**Supplemental Detailed Comments
Regarding the Department of Toxic Substances Control
Draft Program Environmental Impact Report
on Cleanup
of the Santa Susana Field Laboratory
by
the Committee to Bridge the Gap
and
the Natural Resource Defense Council
14 December 2017**

Santa Susana Field Laboratory, 120894
Figure 3-6
 Potential AOC Exceptions Areas

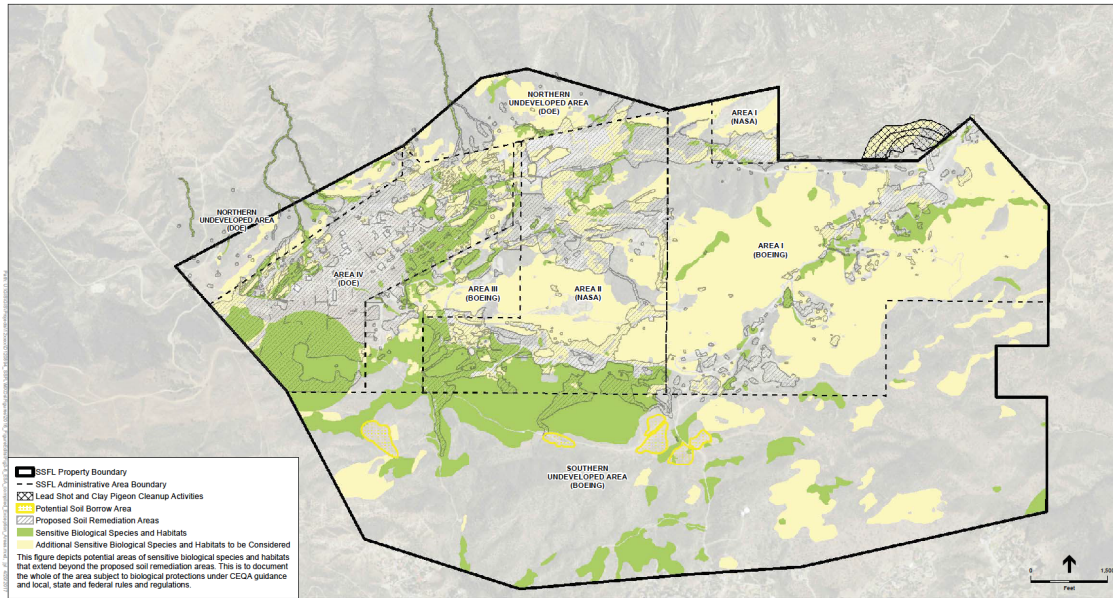
All that one is given that gives any suggestion of the magnitude of the proposed exposure of biological features to harmful pollutants is a single map, reproduced below. No soil volume figures are provided, no contaminant identification or levels, and no comparison to the no observable adverse effects ecoRBSLs to show how much harm would be done by not cleaning up the contaminants that place those ecological features at risk. The PEIR is silent on the harm to the environment from exempting contamination from cleanup. At best one can make an approximation that the contemplated exceptions would prevent a very large fraction of the contamination from being cleaned up, and that they appear to go far beyond the exceptions allowed in the AOCs.

The problem of “hiding the ball,” in violation of CEQA, is exacerbated by the failure of DTSC to make available the referenced material upon which the conclusory claims such as this critical map are based. In small print at the bottom of Figure 3-6, the sources are identified in the most cursory of ways: “SOURCE: DOE 2012; Boeing/MWH 2016; USFWS 2016; ESA 2016.” However, not one of these has been made publicly available. Indeed, not one is even listed in the references for this chapter. There is thus no way to independently ascertain the validity, or lack of same, of any claim documented on the map as to contaminated areas that are purported to be exempt from cleanup. And yet, this single map, entitled “Proposed AOC Exception Areas,” is perhaps the most important aspect of the entire PEIR, and its validity and the environmental impacts that flow from it – exempting vast portions of SSFL contamination from cleanup—cannot be independently assessed. It appears to come primarily from the RPs, who have a vested interest in getting out of cleanup obligations. The impacts for public health and the environment could be immense, yet the bases for it, the level of contamination in various areas that would thus not be cleaned up, and the consequences of continued pollution on biological receptors and the public, are shielded from public review.

The figure is contradictory, but no explanation is available for the contradictions. The green highlighted areas are called “sensitive biological species and habitats,” while the yellow areas are called “additional sensitive biological species and habitats to be considered.” What the difference, if any, between the two might be is unexplained. The legend also says, “This figure depicts potential areas of sensitive species and habitats that extend beyond the proposed soil remediation areas.” But that does not appear to be what the figure depicts; instead it shows vast areas of proposed soil remediation areas that are suggested to not get remediated. Lastly, the legend asserts “This is to document the whole of the area subject to biological protections under CEQA guidance and local, state, and federal rules and regulations.” But these are not identified; to the extent one can ascertain the matter from the limited information disclosed, none of that guidance or rules or regulations bars the cleanup from occurring; and the AOC’ biological exemption is far more narrow, restricted, as indicated above, to a USFWS Biological Opinion that forbids a particular place from being cleaned up because to do so would violate sections of the Endangered Species Act and there are no mitigations or alternatives available, which hasn’t happened.
